ADDENDUM #2
Sanitary Sewer Rehabilitation 2026

This addendum is intended to change a 10" Sectional CIPP liner into a full-segment CIPP liner and make a correction to the diameter of the sewers shown on Sheet 10 of the plan set. One additional sewer line was added to the project scope on Sheet 10.

MERIDIAN TOWNSHIP
SANITARY SEWER REHABILITATION 2026

SHEET
10/21

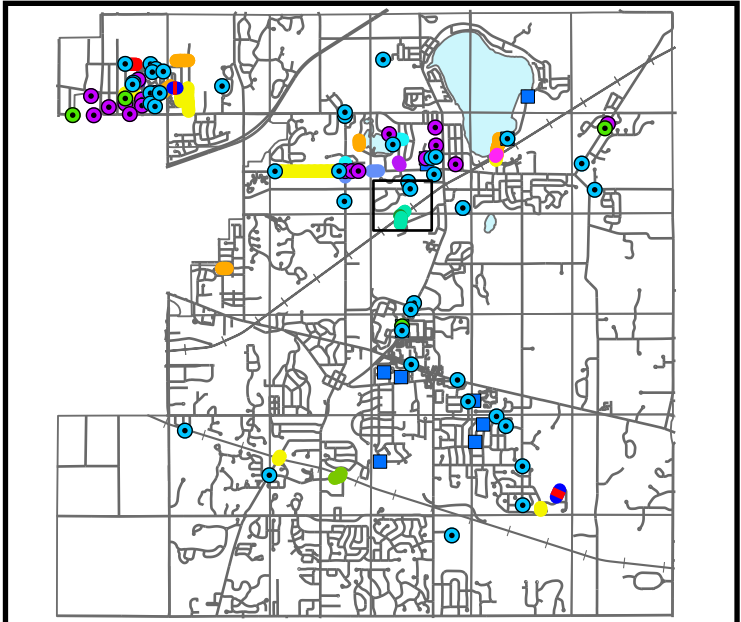
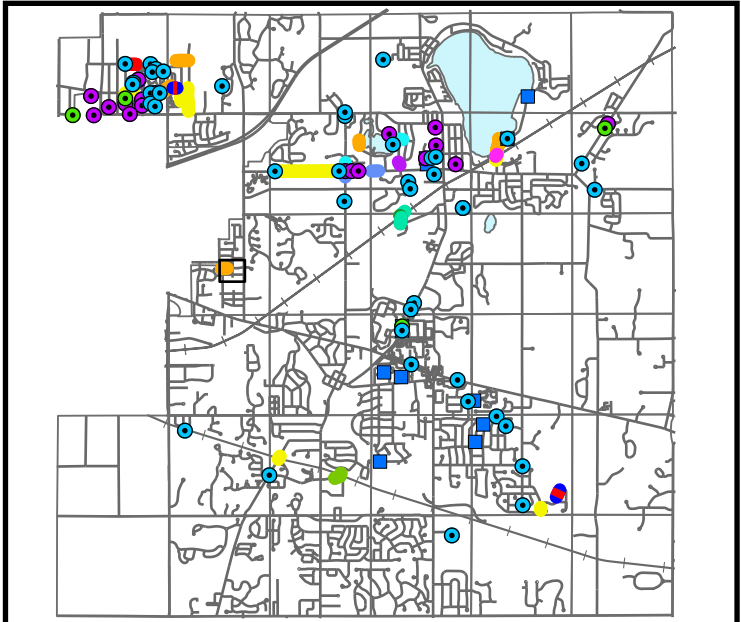
- 2) A 36" diameter segment of sanitary sewer on Sheet 10 was corrected to be 24" after a field survey. One additional 24" CIPP lining segment was added to the project scope in CIPP Priority Index #2, shown on Sheet 10.

- a. The total amount of 24" CIPP lining is 665 LF. The corrected amount of 36" CIPP lining is one segment of 110 feet.
- 3) The 10" CIPP Sectional Liner(s) called for on Sheet 21 have been converted into a full-segment CIPP lining, adding 290' of 10" CIPP lining.

Sewer, CIPP, 24"	665 LF
 Sewer, CIPP, 36"	110 LF
 Manhole, Liner	2 EA
